# DESIGN MEMORANDUM NO. 9

## COOPER RIVER REDIVERSION PROJECT

# INTAKE AND TAILRACE CANALS

JUNE, 1976

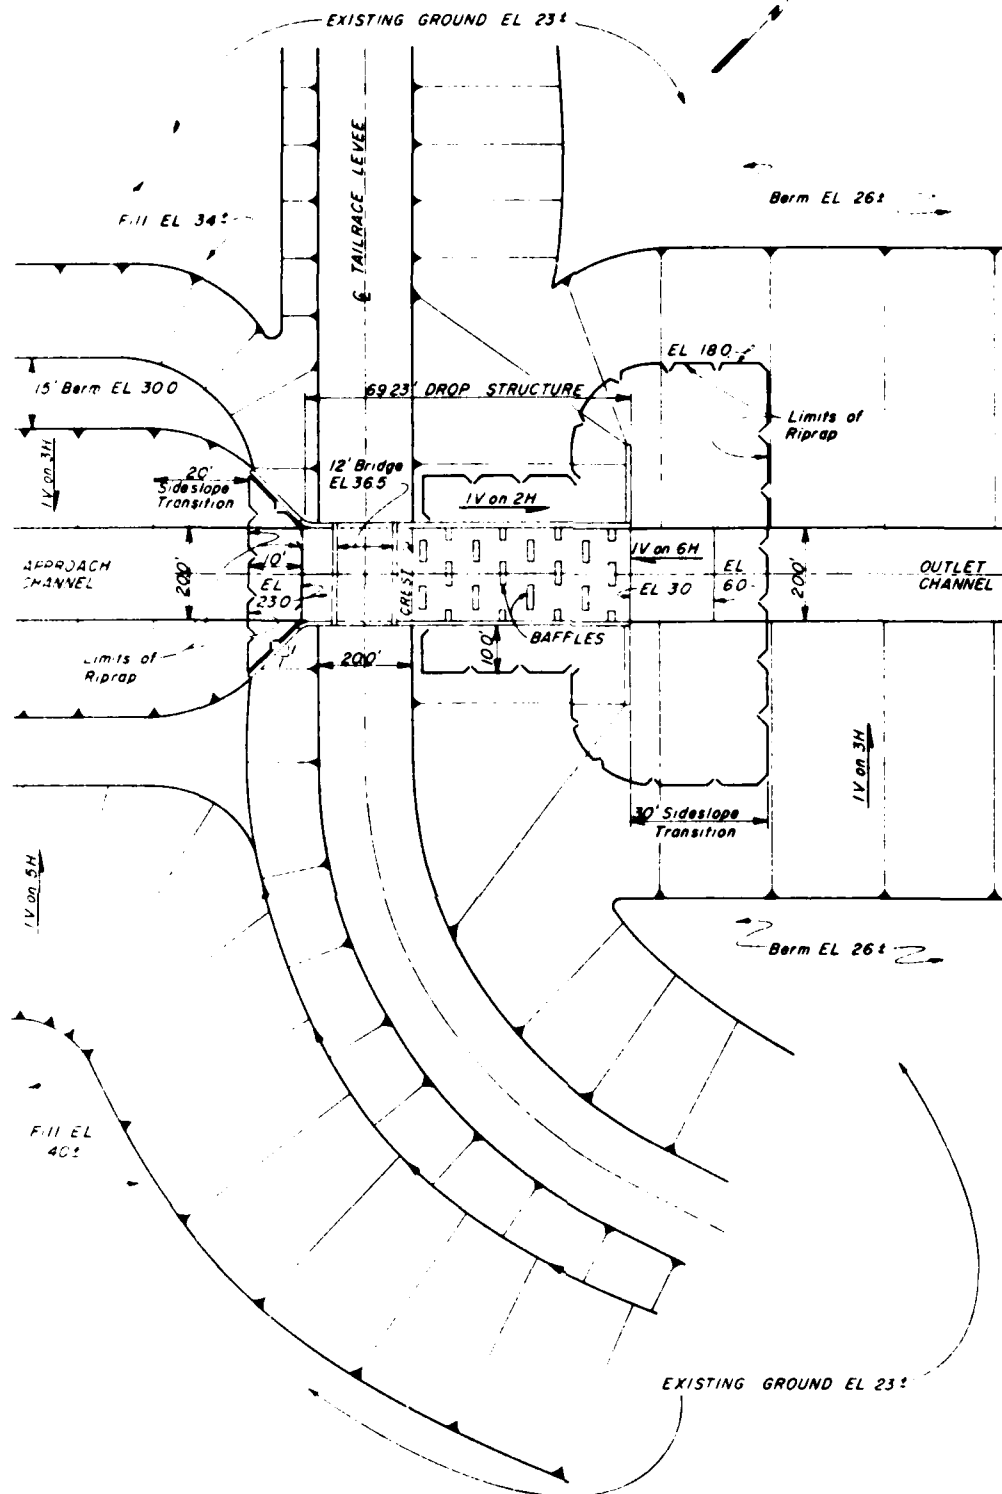
i. Plate 16. The riprap blanket on both the channel bottom and side slopes of the outlet channels for the three drop structures should be extended to provide a total length of at least 50 feet to prevent undermining the structures. The upstream approach channels should be riprapped at least throughout the side slope transition. The outlet channel geometry for structures D-2 and D-3 should be modified so as to be similar to structure D-1; i.e., they should have a 20-foot horizontal section just downstream of the chute before transitioning up to meet the channel bottom.

i. Paragraph 1i. Concur with first and second sentence. In regard to outlet channel geometry for structures D2 and D3, it is expected that both structures will be on rock; therefore, it is believed that no horizontal section is necessary. However, if future borings do not indicate rock, the outlet channel geometry will be revised to conform with D1.

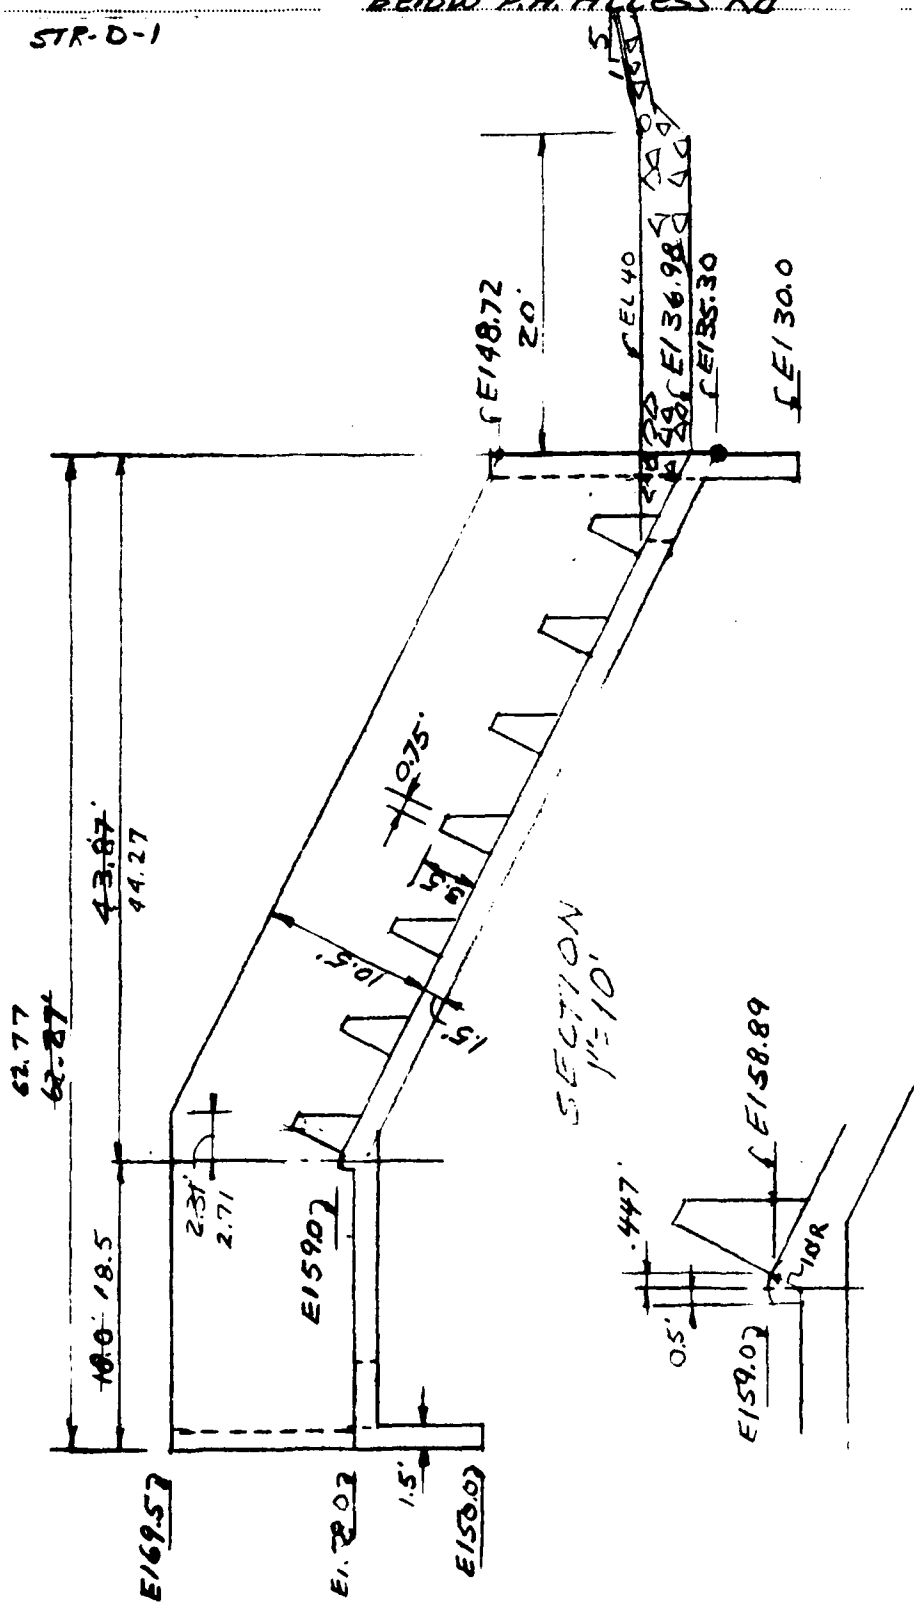
b. Sheet 3. A more conservative and realistic uplift assumption would be based on head loss along the shortest flow path from point a to point h (i.e. straight lines a to f to g to h). Uplift at a point on the structure would be equal to the head at a point on the flow path directly under the point on the structure with appropriate adjustment for difference in elevation.

c. Sheet 4 of computations.  $P_{10}$  is indicated to be "0 due to 1 on 2 slope." Since this slope is steeper than the angle of internal friction ( $\phi = 20^\circ$ ), if cohesion is neglected,  $P_{10}$  would not be zero, however it would be small and could reasonably be neglected. However, in calculating  $P_{13}$  the effect of the sloping backfill (1 on 2 slope) should be considered.

d. Sheet 5 of computations. In the last line "tan  $65^\circ$ " should be "tan  $55^\circ$ " ( $\phi + 2 = 20^\circ + 35^\circ = 55^\circ$ ). This will result in about a 20% reduction in  $P_{18}$ .

e. Sheet 6 of computations. It appears that only 2' of the upstream wing projections were used in computing the passive resistance. Computations on sheet 2 indicate that the upstream wings project 5'. Additional passive resistance appears to be available by utilizing the 5' projection. However, development of full passive resistance at the upstream end of the structure will impose an internal tensile stress on the structure since most of the driving forces are applied on the downstream sloping portion of the structure. It appears that the first line portion of the computation of  $P_{20}$  should be
